NEMOURS SPMP AMENDMENT

SUMMARY

<p>Owner Nelson Roque The Nemours Foundation</p> <p>Applicant Nelson Roque The Nemours Foundation</p> <p>Project Planner Wes Shaffer</p> <p>Updated: February 8, 2016</p>	<p>Property Location: The subject property is located north of Nemours Parkway, east of Lake Nona Boulevard and south of Central Florida Greenway (SR 417) (±59.99 acres, District 1).</p> <p>Applicant's Request: Amendment of Specific Parcel Master Plan (SPMP) for Lake Nona Nemours Children's Hospital within Lake Nona Medical City to develop additional surface parking. The proposed parking lot addition is 3.11 acres.</p> <p>Staff's Recommendation: Approval subject to the conditions in the staff report.</p>	
---	--	--

PROPOSED DEVELOPMENT PLAN

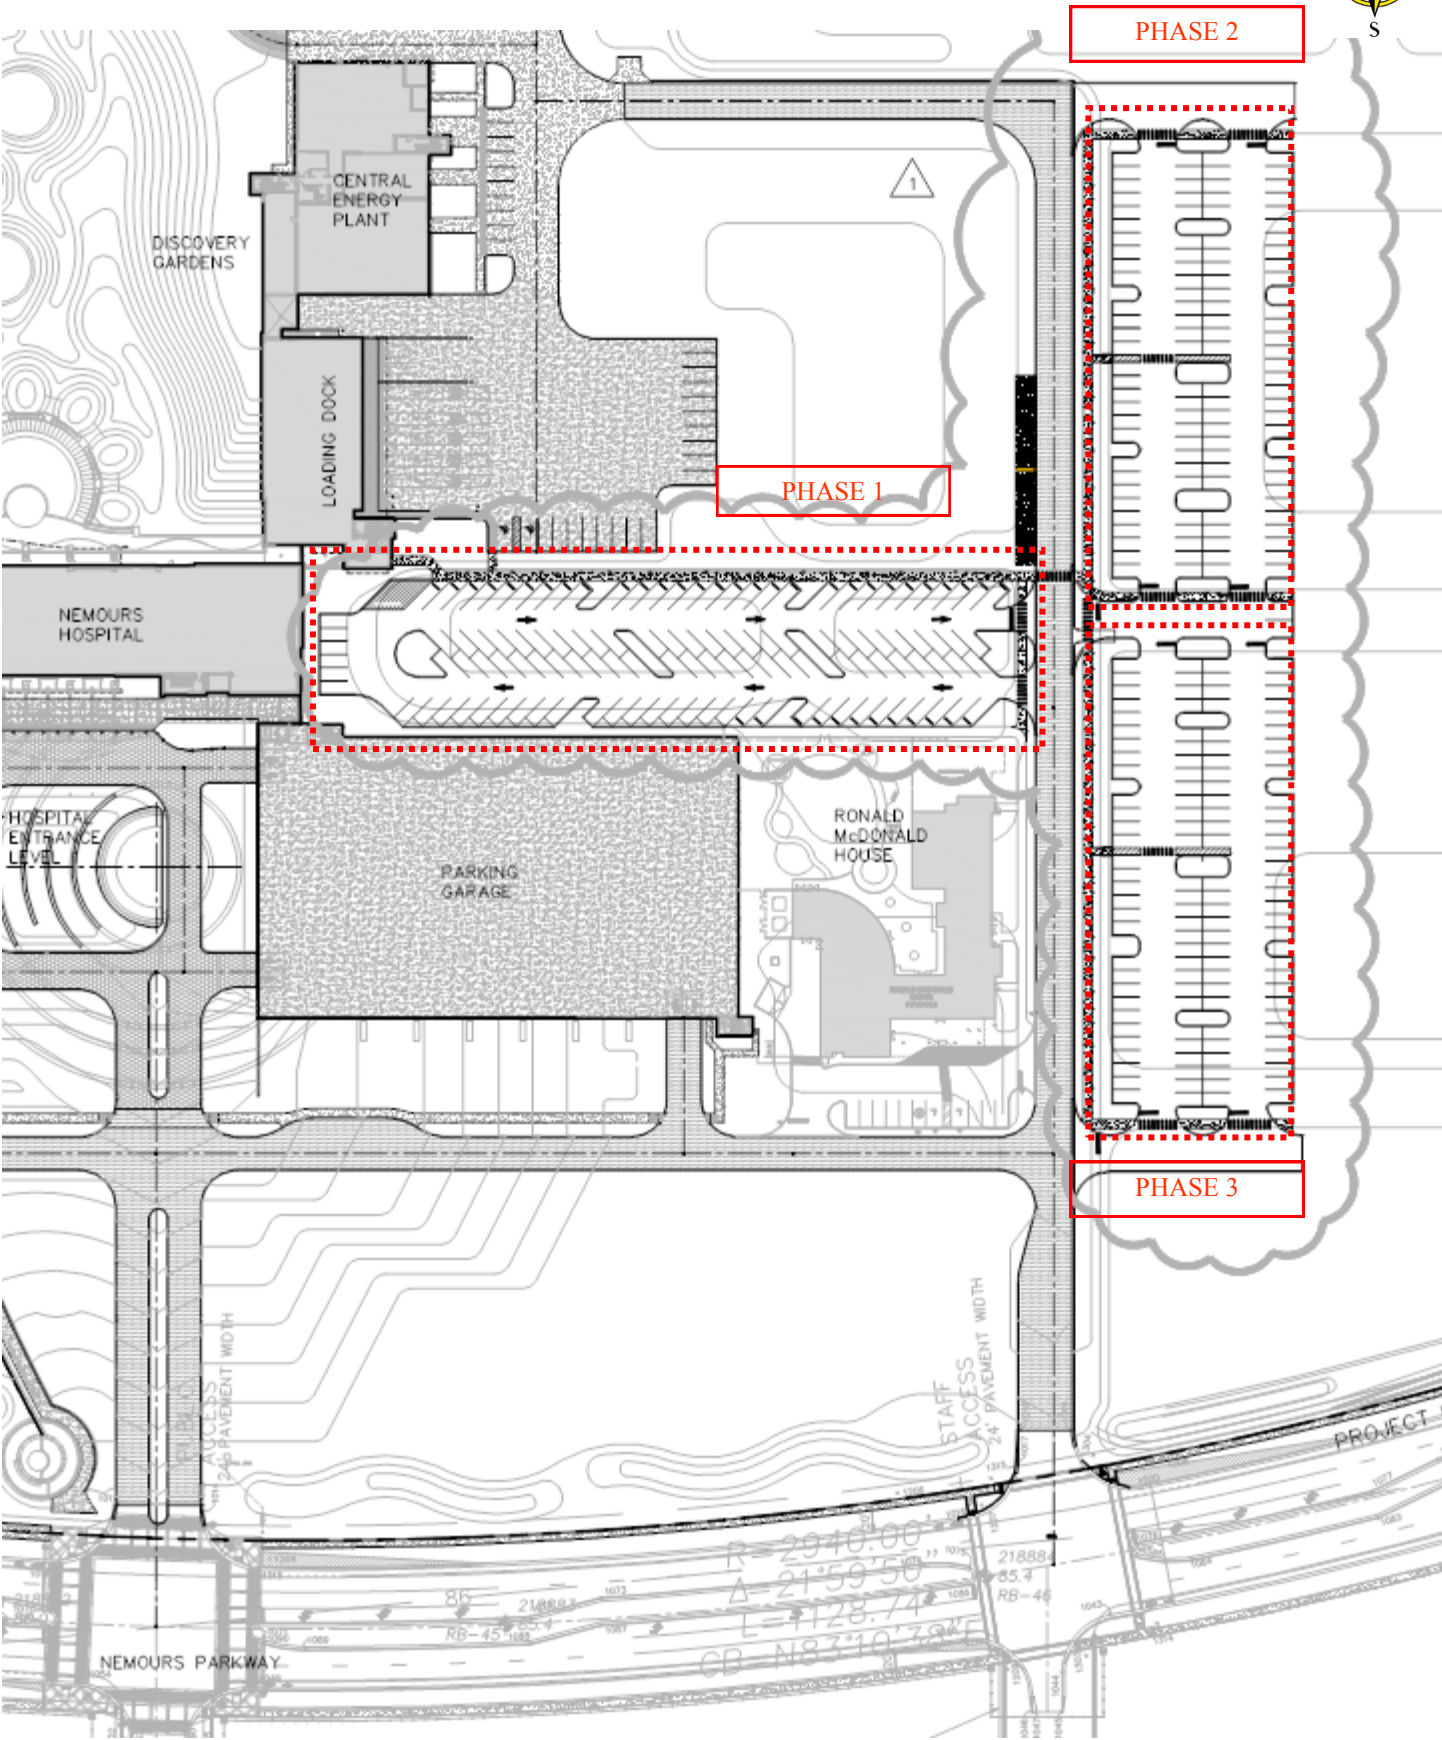
The proposed parking lot must comply with Orlando Land Development Code (LDC) and Engineering Standards Manual (ESM) requirements. Refer to LDC, Chapter 61, Part 3, for parking and loading standards. The proposed parking lot shall be redesigned to meet the following requirements: Provide angle of parking and ensure that requirements in Orlando LDC 61.309 are met.

The plans do not show proper fire department access roadways to the building. Roadways shall have all-weather driving surface, capable of supporting the load of fire apparatus, shall be at least 20 ft. in width, and shall have a minimum vertical clearance of at least 13 ft. 6 in. Please submit revisions correcting this deficiency. [NFPA 1: 18.2.3.1]

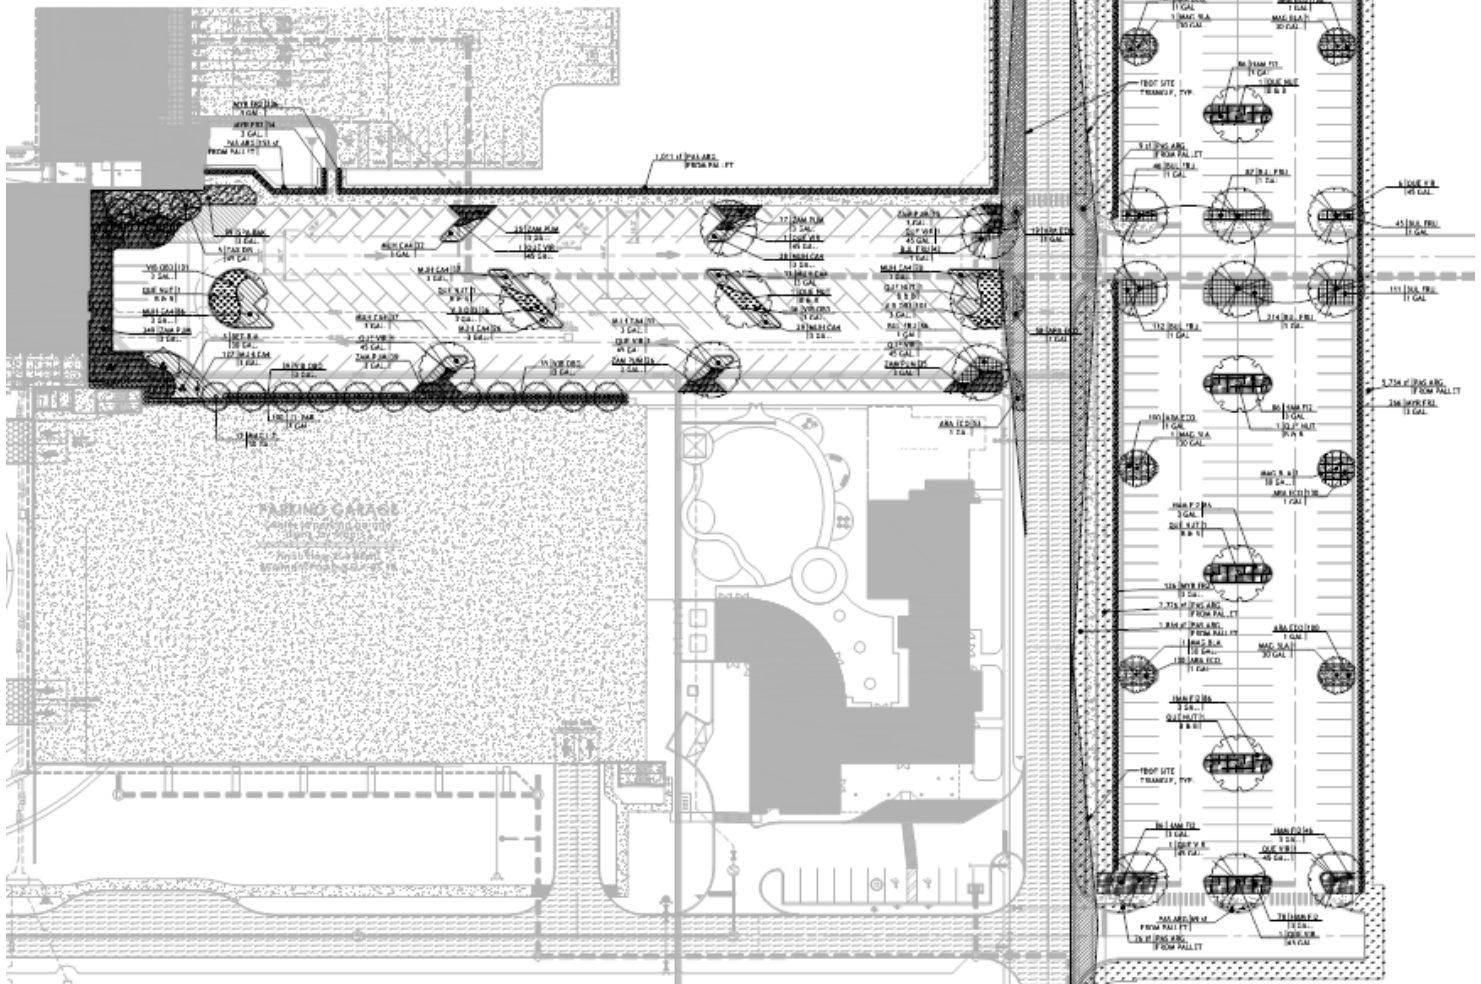
Please note type of mulch. Cypress mulch is not allowed.

Drivers' sight lines, per the Orlando Engineering Standards Manual, are required to be shown on the landscape plans at the street.

The irrigation system must meet the requirements of Code Section 60.223 (f), and Section 60.229 through 60.232.
